Re: Proposed Facility
South Perry and
East Maumee Avenue

We have reviewed the preliminary "Plot Plan" for the above referenced facility and will use this correspondence as a guide for your Engineer regarding the site improvement design.

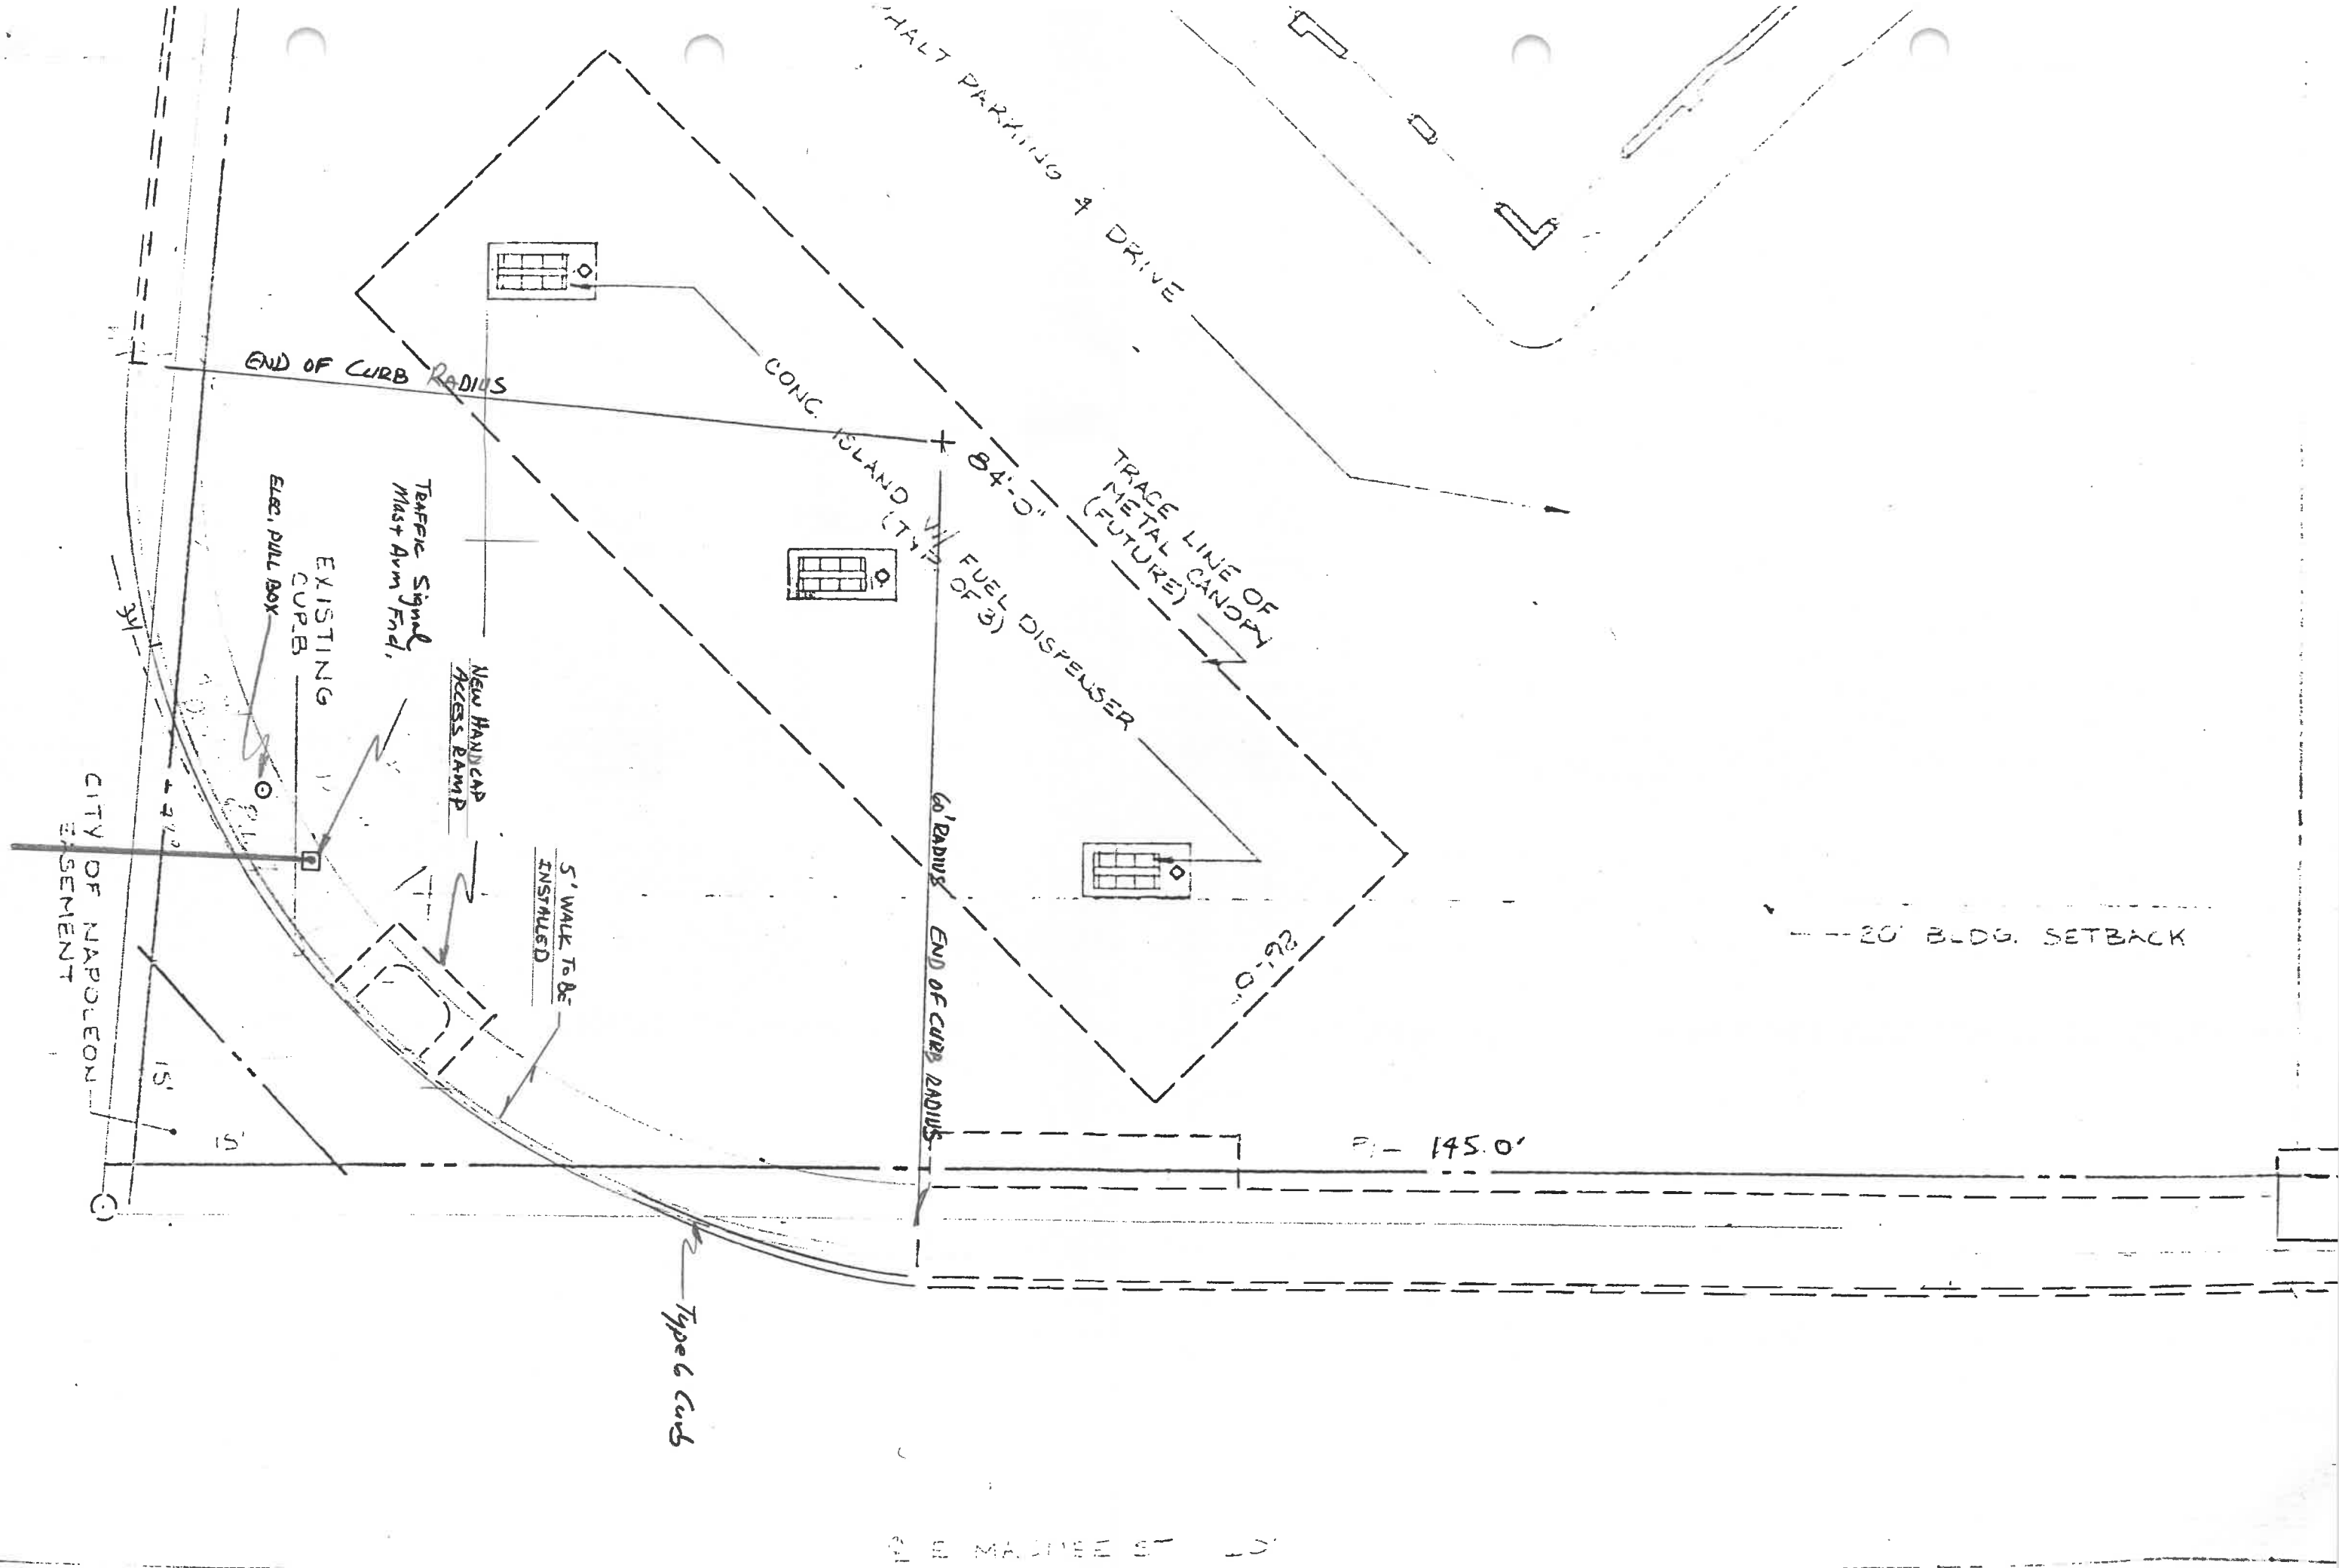
The site plan should show the boundary survey as well as all existing easements. It should also be noted that we had been in contact with Mr. Kruse regarding the removal of the existing sign/sign base and the widening of the pavement and therefore, the City of Napoleon will need to secure this easement. The site plan should show existing elevations as well as proposed grades.

The City of Napoleon will require that all water within the Owners property will be collected by a storm sewer collection system and then tied into the existing storm drainage. (There exists a twelve (12) inch sewer along East Maumee Avenue and a thirty-six (36) inch sewer along

South Perry Street). Drainage calculations shall be submitted with the site submission.

The City of Napoleon does not have any records indicating where the location of the sanitary sewer service was plugged at the time of demolition, but if this tap cannot be found or the Owner desires to install a new service, there does exist a 36" x 29" brick sanitary sewer running along the northerly property line. The tap and all line extension will be done by the Owner's representation.

There does exist a eight (8) inch water line along East Maumee Avenue and based on the required service size (1", 1-1/2", 2" or greater) the City of Napoleon will tap the existing line and extend it to the right-of-way where there will be a shut off valve. (See attached Fee Schedule).

The City will require that all new curb (Type 6) along the edge of pavement and the replacement of a five (5) foot sidewalk along the new and existing curb. This walk will need to be six (6) inches thick in the driveway areas. Regarding the drive approaches, we would prefer to see a thirty-five (35) foot approach off of East Maumee Avenue as far back from the intersection as possible. Along South Perry Street we would like to keep the opening as narrow as possible, but feel that your request for seventy-five (75) feet is probably justified. We do not want to begin this driveway approach any closer than the present radius termination.
